#### **Addendum 98 – Regulation No. 99**

#### **Revision 3 – Amendment 3**

#### **Uniform provisions concerning the approval of gas-discharge light sources for use in approved gas-discharge lamp units of power-driven vehicles**

"10. Colour

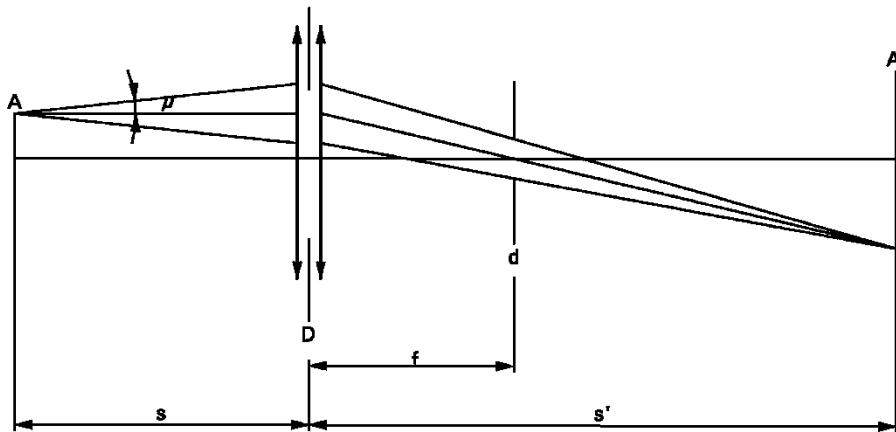
*Paragraph 10.*, delete the figure and amend to read:

The colour of the light source shall be measured in an integrating sphere using a measuring system which shows the CIE chromaticity co-ordinates of the received light with a resolution of  $\pm 0.002$ ."
